**COUNTY OF VENTURA
PUBLIC WORKS AGENCY**

Addendum No.2

Subject: **Project Name:**
Ventura County Medical Center Mammography Rooms and Needle Biopsy Room
Specification No.: CP11-05
Bids to be Opened: June 9, 2011

SUSPENDED CEILING ATTACHMENT		MAMMO AND NEEDLE BIOPSY ROOMS	
FACILITY: VCMC 3291 LOMA VISTA ROAD, VENTURA CA		OSHPD #: SS-101318-56	
ADDEN. #2	DATE: 5/31/11	SCALE: NTS	ATTACH: X2

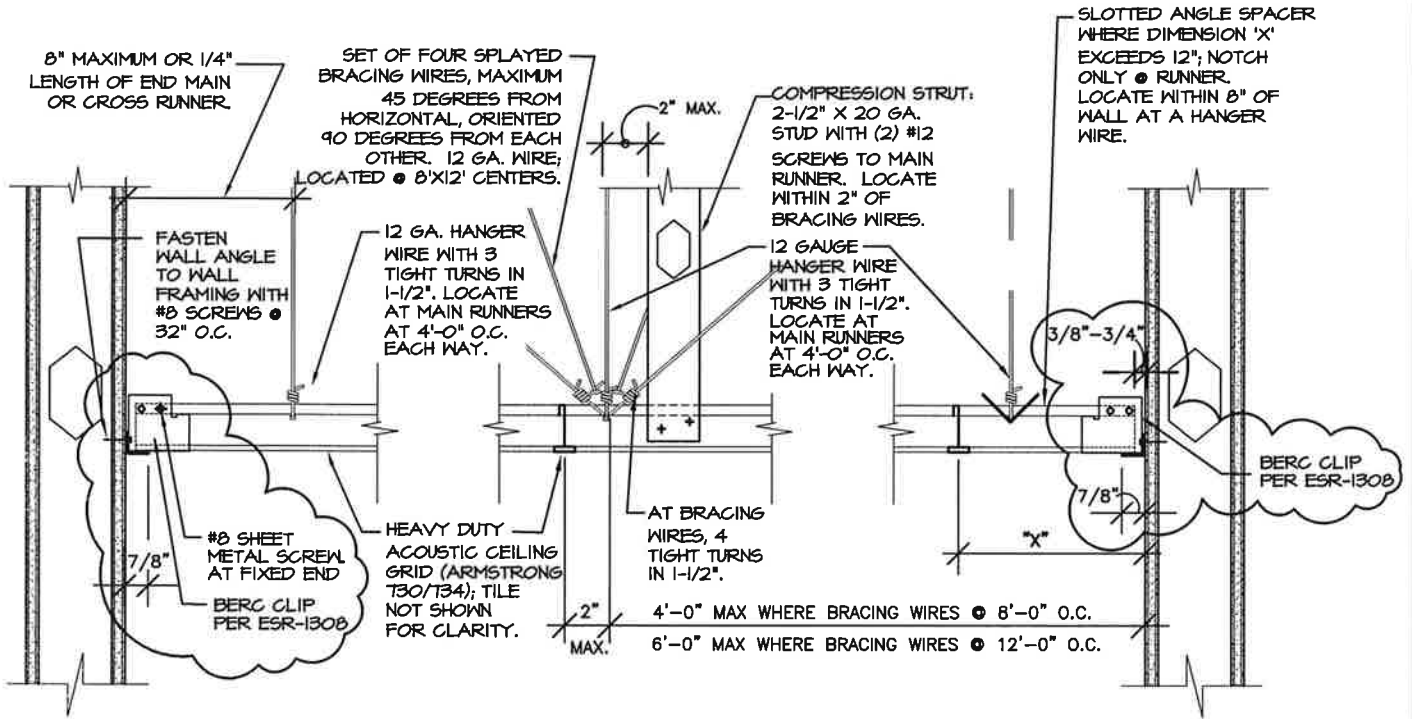
1. On Rasmussen & Associates Drawing Detail 4/A4.3, **Typical Acoustic Ceiling**, dated 03-30-11, delete E, **Wall Angle "Connected"**, D, **Lateral Bracing**, and C, **"Free End" Wall Angle** and substitute Rasmussen & Associates Drawing X2, **Suspended Ceiling Attachment**, dated 5/31/11, attached.
2. On Rasmussen & Associates Drawing A4.3, **Details & Ceiling Notes**, dated 03-30-11, on the **Acoustic Ceiling Notes**, add the following paragraph:
 - M. Concrete Anchors Testing Requirements:
Hanger wire shot pins: Test 1 in 10 for 200# tension.
Bracing wire expansion bolts: Test 1 in 2 for 440# tension.
If any anchor fails, all adjacent anchors shall be tested.

CHANGES TO DETAIL ARE CLOUDED.
(NO CHANGES TO DETAILS 4A & 4B/A4.3)

"CONNECTED"
WALL ANGLE

LATERAL BRACING

"FREE END"
WALL ANGLE

TYPICAL ACOUSTIC CEILING

REFERENCE DETAIL 4 SHEET A4.3
